Document: T10/01-328r2 Date: 7 January 2002
 To: T10 Committee Membership
 From: Edward A. Gardner, Ophidian Designs
 Subject: Response to T10 Letter Ballot comments on SRP

Figure 0.1 - IB I/O unit example

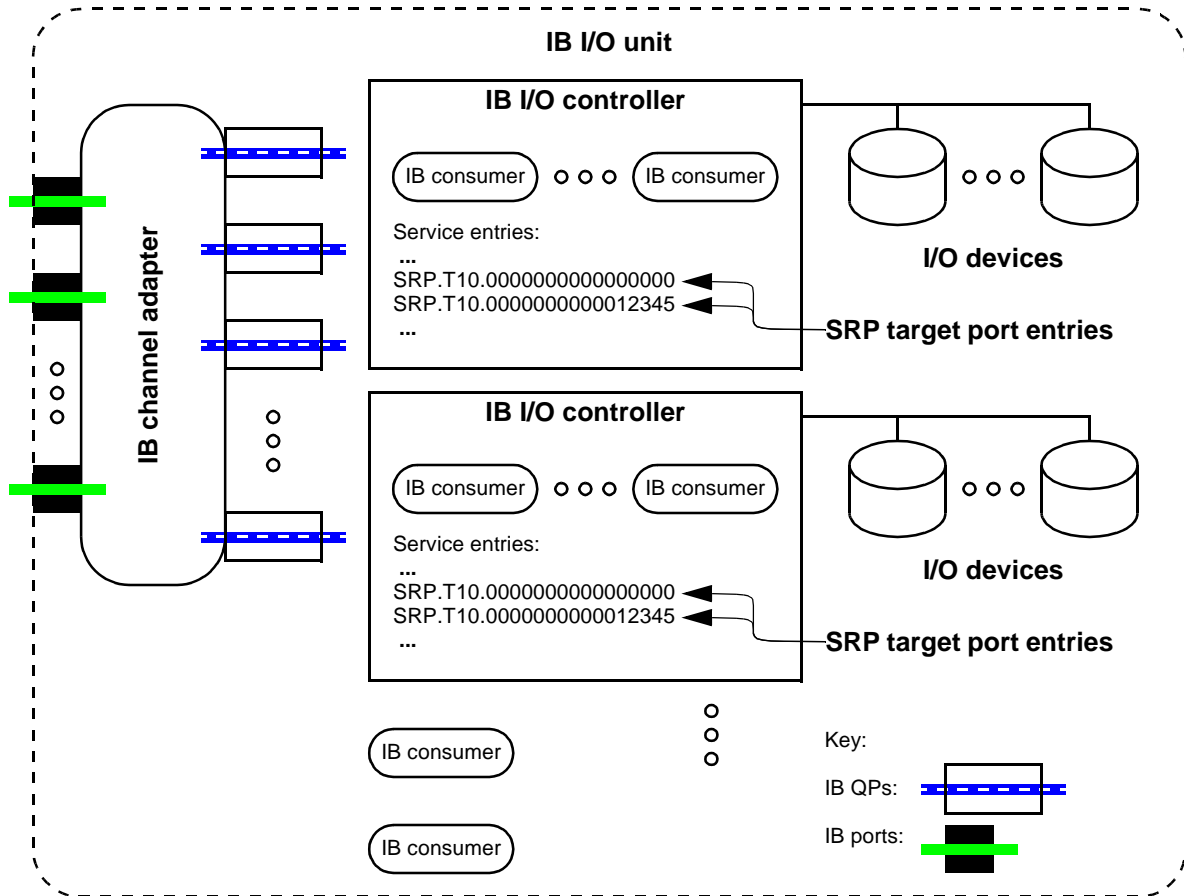
Figure B.3's equating of 'SRP Target Ports' with 'IB consumers' is problematic. A 'target port' is a sort of service access point---somewhere where interested parties initially go to obtain service, but without any implication that that's where the service is actually provided. (In IB, it's

Notes from 28 Nov 2001 teleconference: show service entries in figures B.2 and B.3, in accompanying text explain that each service entry identifies an SRP target port.

The following is an attempt at a modified figure B.2 and the text describing service entries that identify SRP target ports

Figure 1 - SCSI document relationships

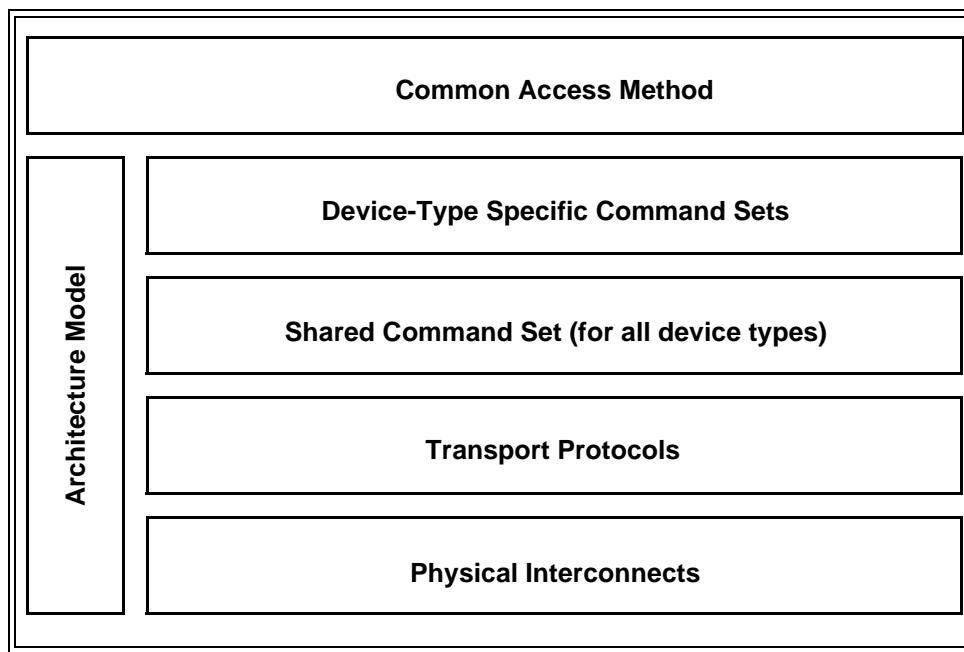
Delete CAM from figure 1 Delete these SCSI-2 standards from the example standards list:
Serial Storage Architecture SCSI-2 Protocol SSA-S2P [ANSI X3.294:1996] Common Access Method: SCSI Common Access Method CAM [ISO/IEC 9316-421] [ANSI X3.232:1996]

"Figure 1 shows the relationship of this standard to the other standards?" But it doesn't. The SRP standard is not identified in the figure. Despite the disclaimer, layering of the blocks does suggest a hierarchy, protocol stack and system architecture. But the figure does not indicate the applicability of SRP to the implementation of a SCSI transport, as far as I can tell.

Figure 3 - Example RDMA channel establishment

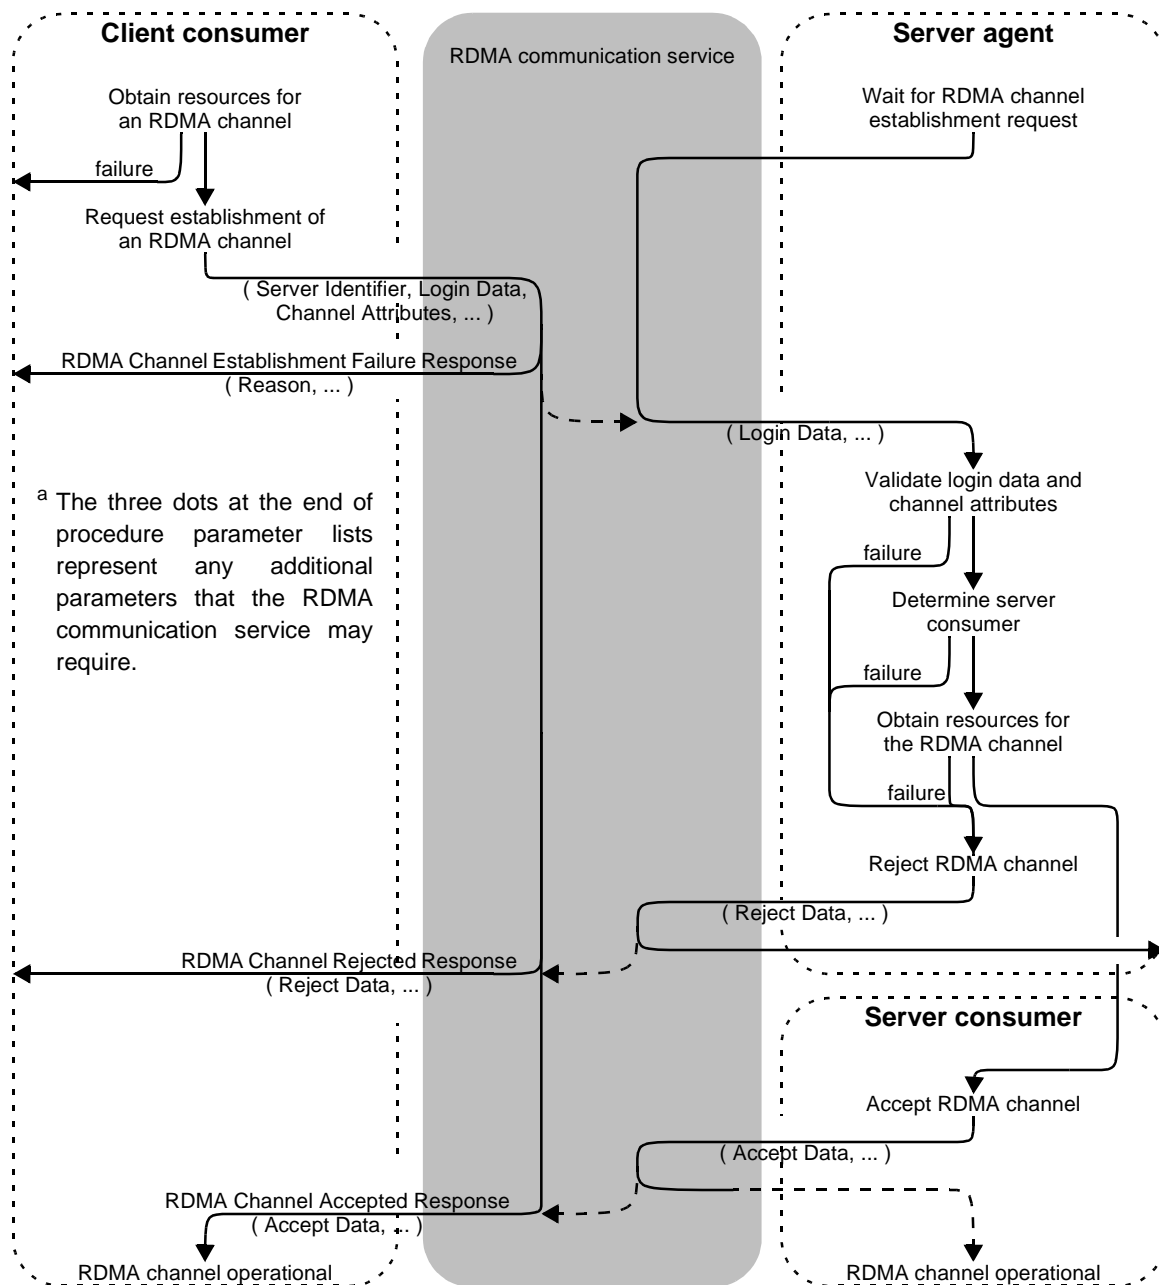
Pages 8 - 11 - section 4.2 - This clause should be broken in subclauses and there should be references added between the steps in the figure and the text descriptions of those steps. This will help the reader relate the figures flow to the text.

Page 9 - Figure 3 - line 40 - The arrow exiting to the right seems to be a dead end. Where does the flow go from there. All the other exit points are clear that one is not.

Figure 4 - Memory descriptor mapping

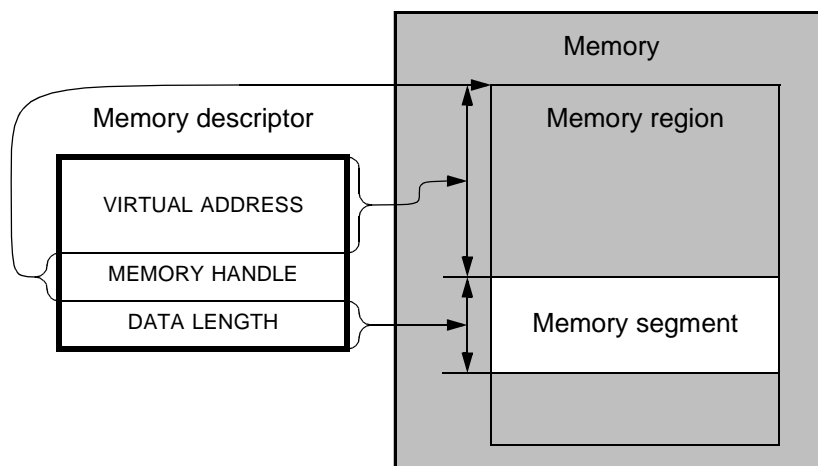
Page 17 - Figure 4 - The way the arrows are pointing for the virtual address implies that it is not the address of the first byte of the memory segment. It currently implies that it is the space from the memory handle to the beginning of the memory segment which is the memory region. It is also not clear as to what the boundaries are of the memory region. The current drawing implies it is only the area above the memory segment. I do not believe that is correct so it needs to be fixed.

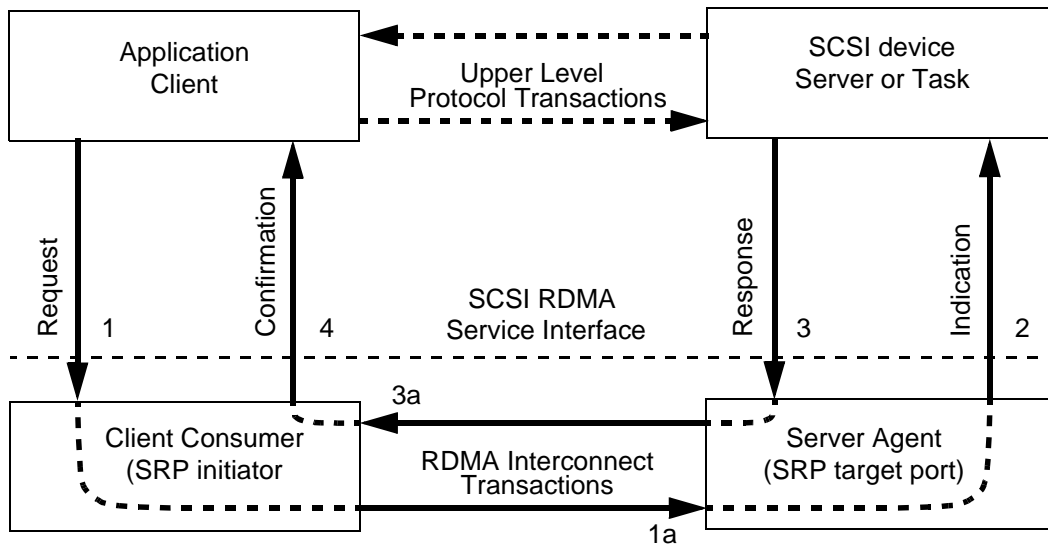
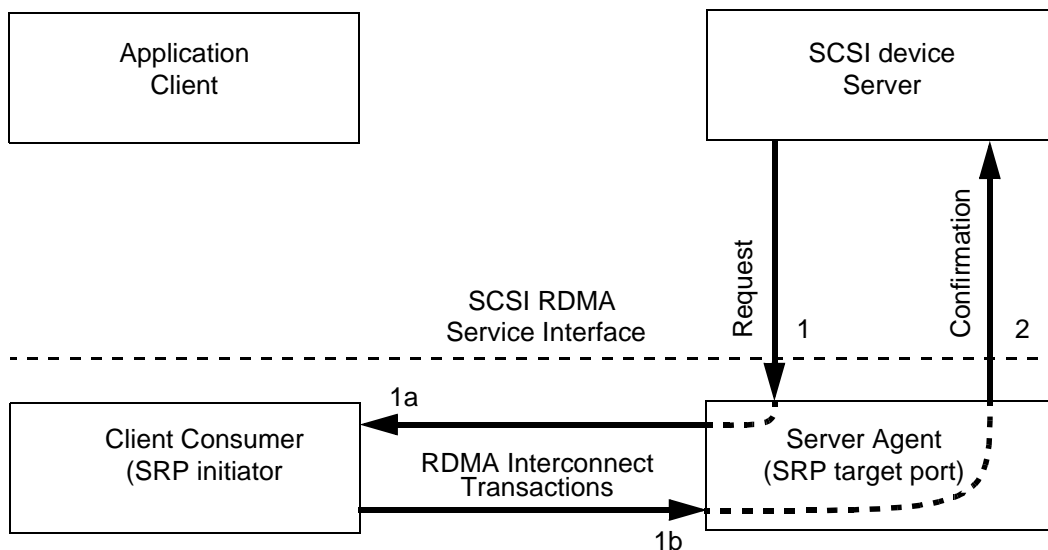
Page 46 - figure A.2 and A.3 - line 15 and 43 - The statement '(SRP initiator' should be '(SRP initiator port)'.

Figure B.2 - IB I/O unit example

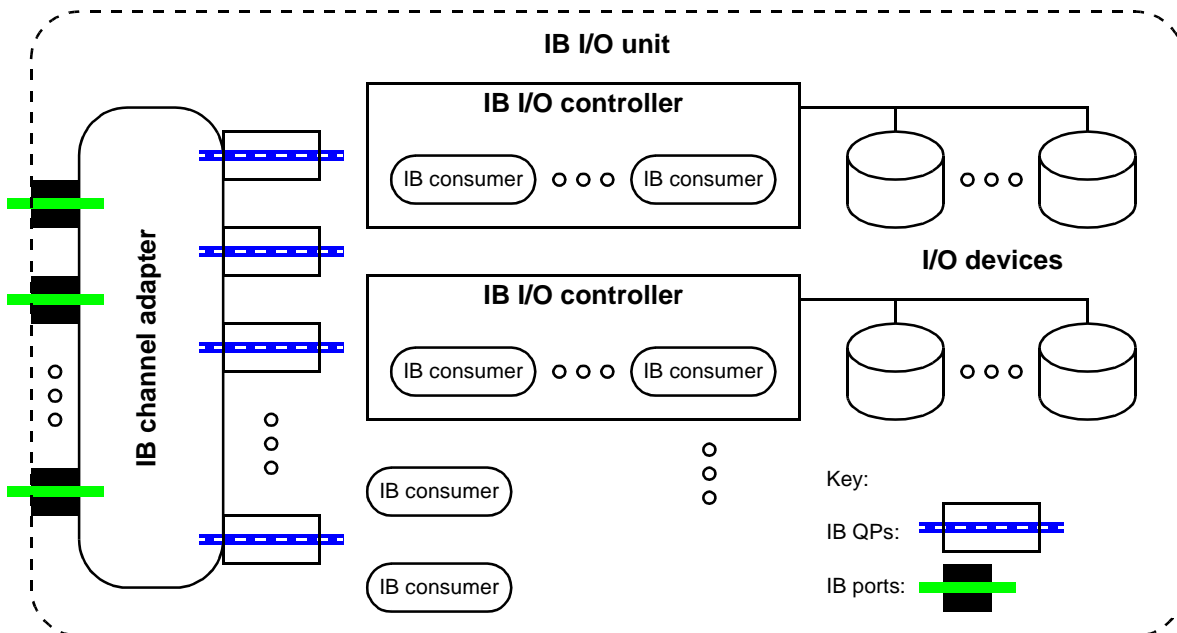
Figure B.2. Can I/O controllers be virtual objects?

Figure B.2. What is the purpose of allowing multiple IB consumers per IB I/O controller? Is it so that multiple IB connections can be terminated within an IB I/O controller? (This relates to the question above about correspondence between QPs and IB consumers.)

Figure B.2. How are shared LUs modeled? Do SRP target ports contain the "task router" function described recently by Penokie? Can two IB I/O controllers have an underlying LU in common, or is this functionality restricted to two IB consumers within the same IB I/O controller?

Figure B.3 - SCSI architecture mapping

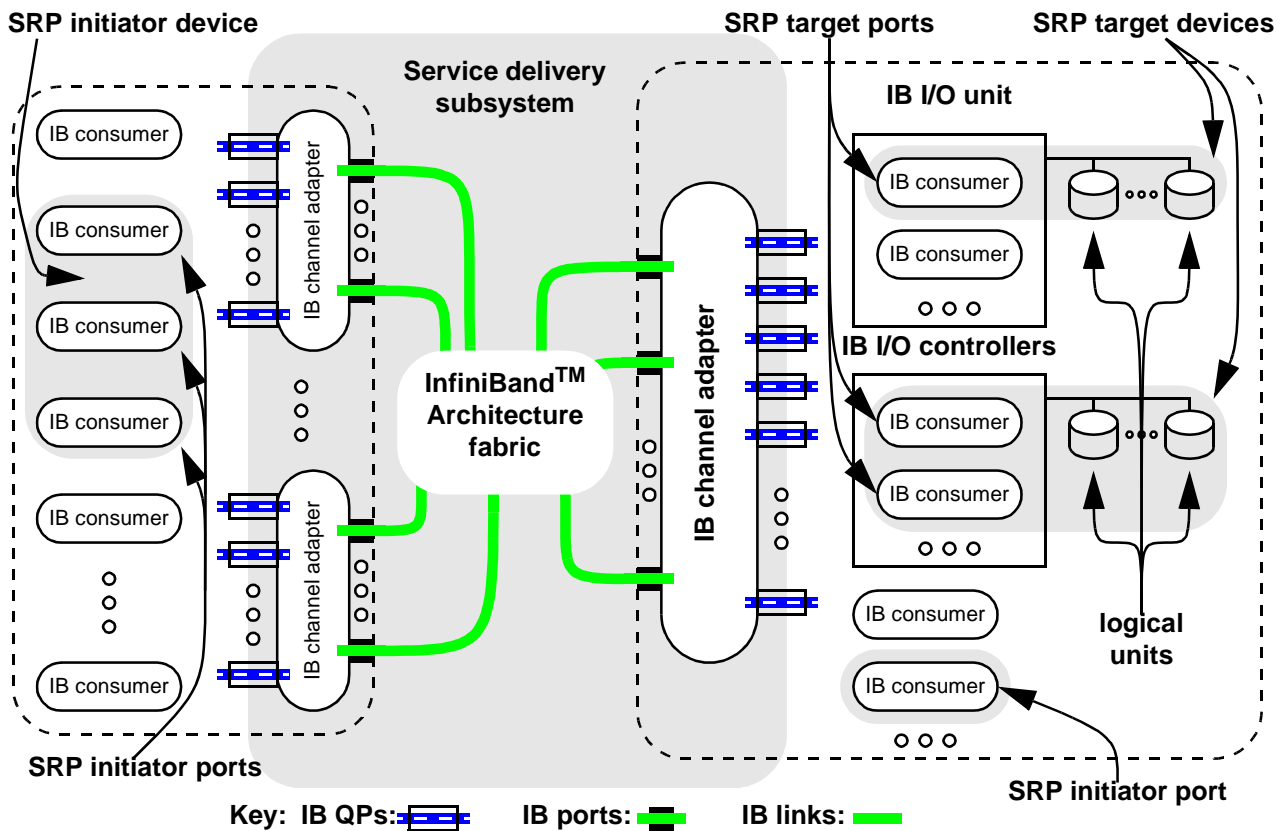
the Connection Manager that receives the initial connection request, interprets the ServiceID contained therein, and performs some magic that results in the instantiation of a QP bound to some entity that actually provides the target services). This target-services-providing entity fits the definition of 'IB consumer'. But the mapping of ServiceIDs-cum-SRP target ports onto such entities is clearly a matter of implementation, and could be one-to-many, many-to-one, or many-to-many Suggested Solution: One possibility: to the left of the IB Consumers show a table/list of service IDs within each IB I/O unit and label these entries as SRP Target Ports; use arrows to show a mapping from the entries to the IB Consumers, with e.g. one Consumer mapped to two IDs and another mapped to one ID to show that the mappings are not always 1 to 1. A further refinement might be to use another set of arrow between the Consumers and the QPs to show that the this mapping is also not 1 to 1

Figure B.3. What is the object indicated by the dashed lines in the initiator model, analogous to the IB I/O unit in the target model?

Figure B.3. and 56-1. Table B.2. The rules for constructing initiator ports seem entirely too lax. The text says, "Initiator port identifier should be constructed?" And then the Table indicates that GUID, for example, is the channel adapter GUID. Is there no meaning associated with the initiator port ID? Is the only design goal that the 16B port ID be globally unique? Will any GUID do at all? If so, let's be explicit about this, and let's not make any suggestions about the origin (and possible meaning) of the port name.

This comment is correct, but it's not immediately obvious how to incorporate it into a legible diagram. Note the further complication introduced by connection redirection. The IB consumer (IB QP and the software, etc. behind it) may be in an unrelated device / node / whatever, it need not be the same channel adapter or even an I/O unit. The sole purpose of the I/O unit and I/O controller is to obtain a service ID, connecting to that service ID may lead somewhere else altogether.
